ECM Calibration: Transmission Software Enhancements

YEAR(S)	MODEL(S)	ADDITIONAL INFORMATION
2016 - 2017	Land Cruiser

REVISION NOTICE

Figure 1. Location of Authorized Modification Label for 2016 – 2017 Land Cruiser

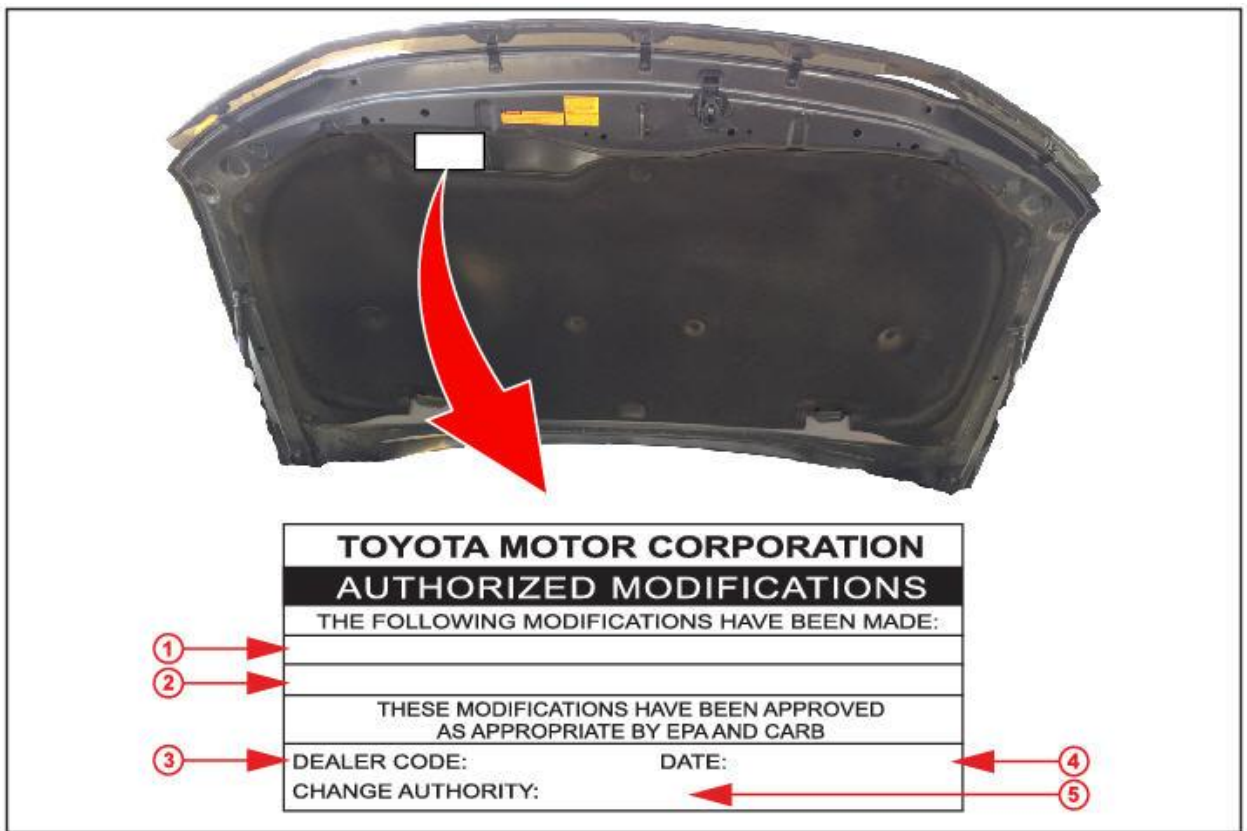
- Check for the Authorized Modifications Label affixed to the vehicle in the location shown below. Confirm if the ECM (PCM) calibration has been updated.

Is the calibration ID listed the latest ECM (PCM) calibration?

4. Install the Authorized Modifications Label.
 - A. Using a permanent marker, enter the following information on the label:
 - ECM part number [Refer to the **Parts Information** section for the **NEW PART NUMBER**]
 - Calibration ID(s) [Refer to the **Calibration Information** section for the **NEW CALIBRATION ID**]
 - Dealer Code
 - Repair Date
 - Change Authority [**This bulletin number**]
 - B. Affix the Authorized Modifications Label to the vehicle at the location shown in Figure 1. The Authorized Modifications Label is available through the MDC, P/N 00451-00001-LBL.
5. Perform transmission initialization.
